# SERVICE BULLETIN

M-1200A

Safety Recall Code 0128

## 2007 XL VOLTAGE REGULATOR

**Figure 1. Safety Recall Code 0128—Kit 94507**

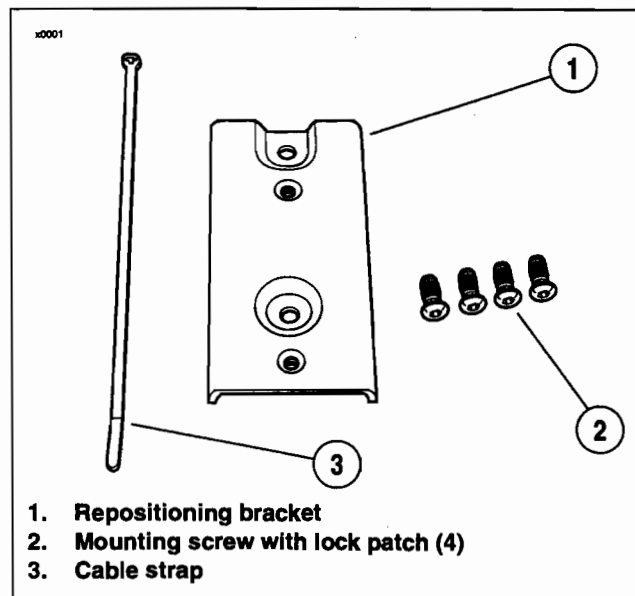
1. Obtain recall kit (Part No. 94507). See Table 1. See Figure 1. This kit consists of a repositioning bracket, four mounting screws (with lock patches) and a cable strap.
2. Position vehicle upright on a suitable lift.

Figure 2. Unbolt and Remove Voltage Regulator

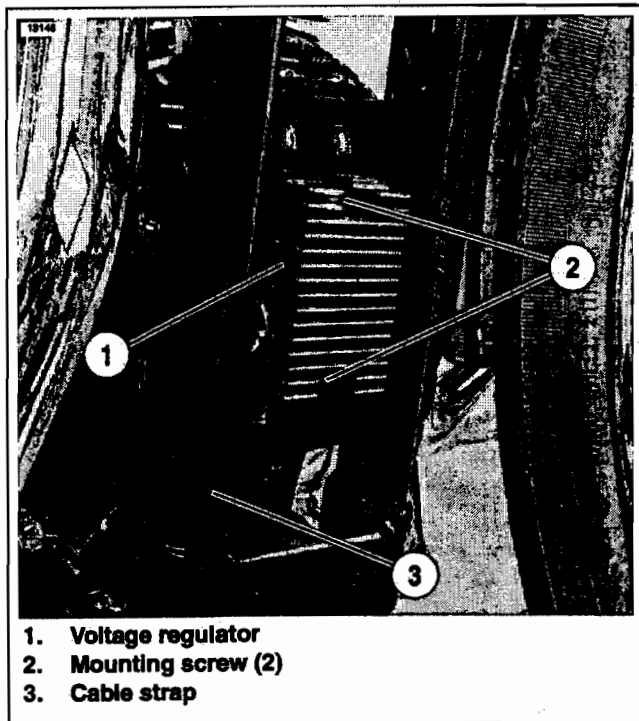
3. Remove Maxi-Fuse.
4. See Figure 2. Cut cable strap (3) that secures stator harness and neutral switch wire to vehicle frame.
5. Remove two screws (2) and voltage regulator (1) from voltage regulator bracket on vehicle frame. Discard mounting screws. They will not be reused. Position voltage regulator to the side, out of the way.
6. See Figure 3. Mount repositioning bracket (1) onto original voltage regulator bracket on frame with two **new** screws (2) from recall kit. Make sure repositioning bracket is oriented as shown in the photo, so that voltage regulator mounting holes (3) are below repositioning bracket mounting holes. Tighten screws to 30-60 in-lbs (3.4-6.8 Nm).

Figure 4. Mount Voltage Regulator

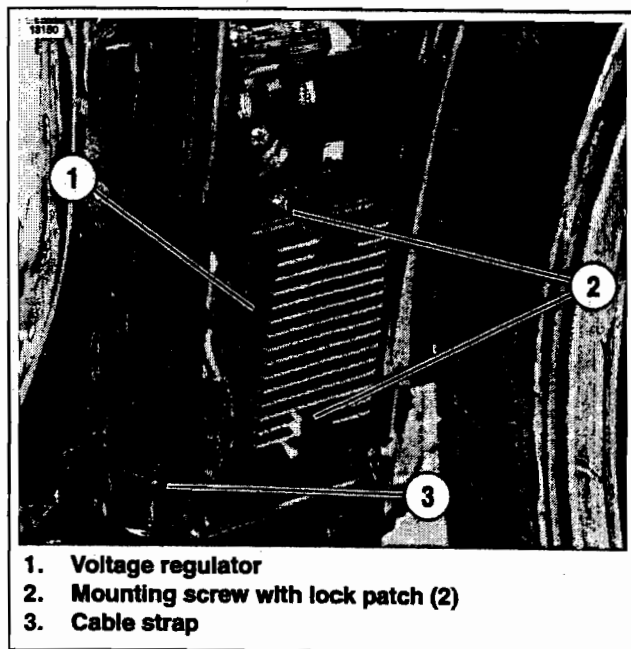
7. See Figure 4. Mount voltage regulator (1) onto repositioning bracket with remaining two **new** screws (2) from recall kit. Tighten screws to 30-60 in-lbs (3.4-6.8 Nm).
8. Locate cable strap in recall kit. Wrap cable strap (3) around stator harness, neutral switch wire and vehicle frame. Tighten cable strap securely. Cut off excess strap material.
9. Install Maxi-Fuse.
